**December 1, 2025 CITY COUNCIL MEETING AGENDA**

**TOPIC:** Consideration and action on a request to establish a Planned Unit Development (PUD) with State Highway 6 Overlay (PUD/SH6) zoning district, for approximately 47.3156 acres of land, proposed for annexation into City of Manvel City Limits, located at the northwest corner of Kirby Drive and State Highway 6/Morris Avenue (Property IDs: 1676950,167695 & 167690).

## STAFF REPORT TO PLANNING, DEVELOPMENT, AND ZONING COMMISSION

# Manvel Crossing Planned Unit Development District

# Exhibit 6 - Multi-Tenant Pylon Sign Elevation

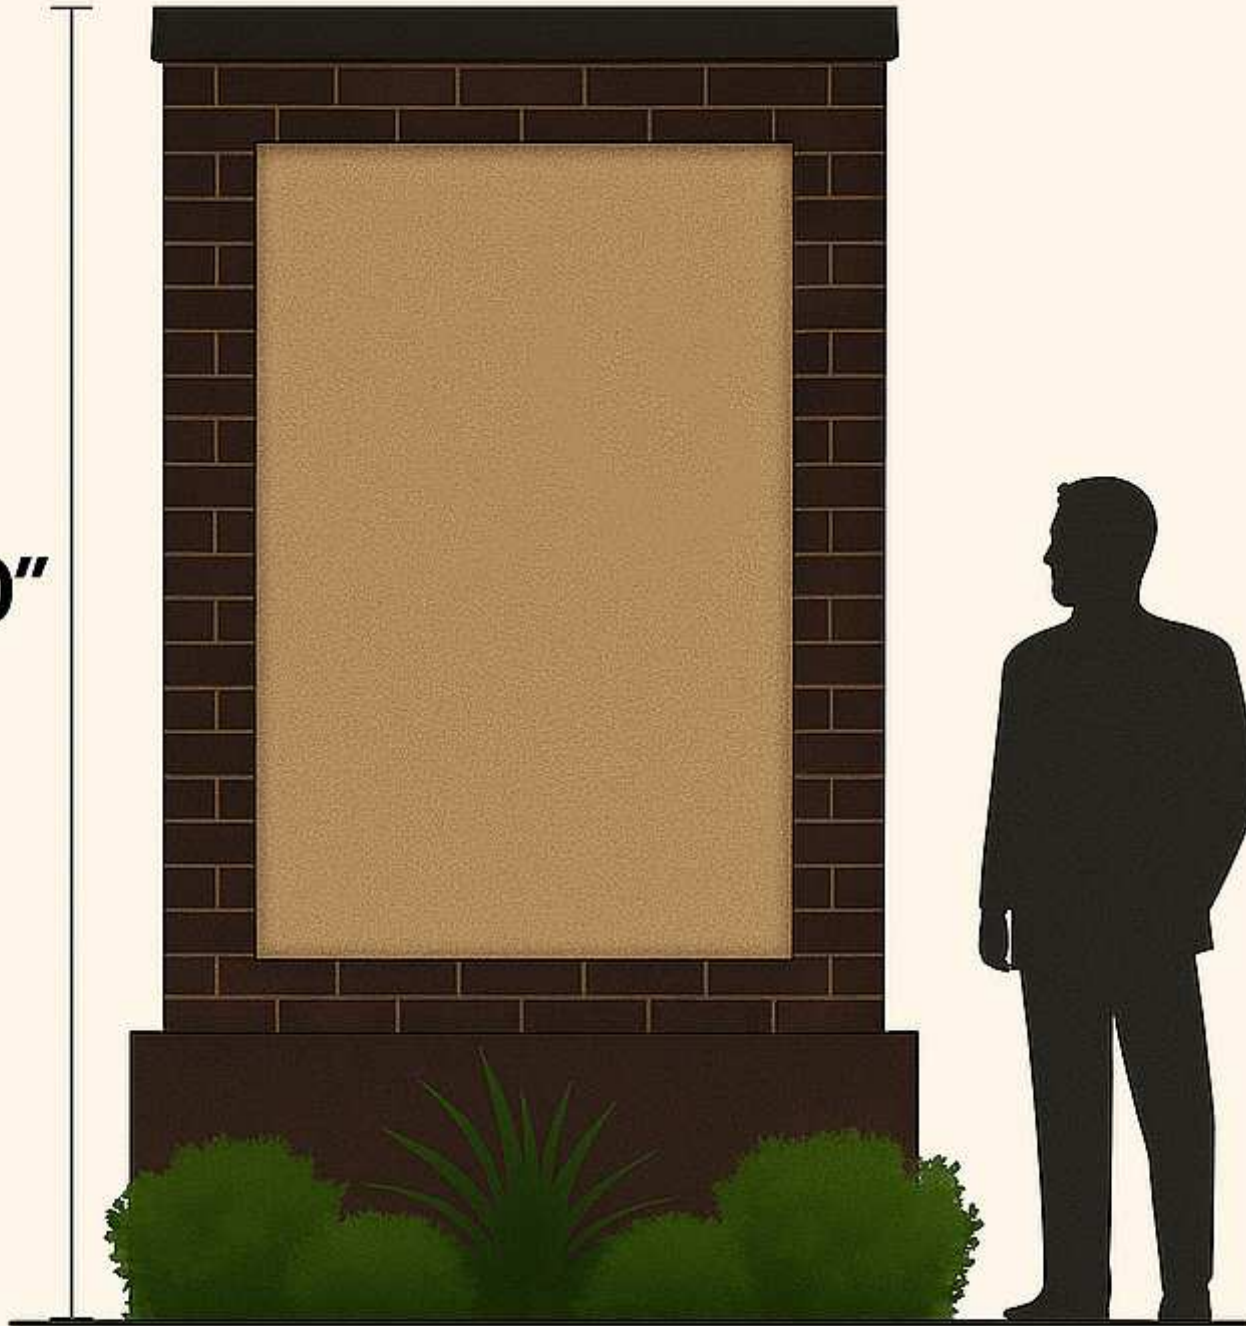
- 5) Pylon sign definition should be revised to clarify that structural poles and pylons of the sign shall be concealed using architectural design features.
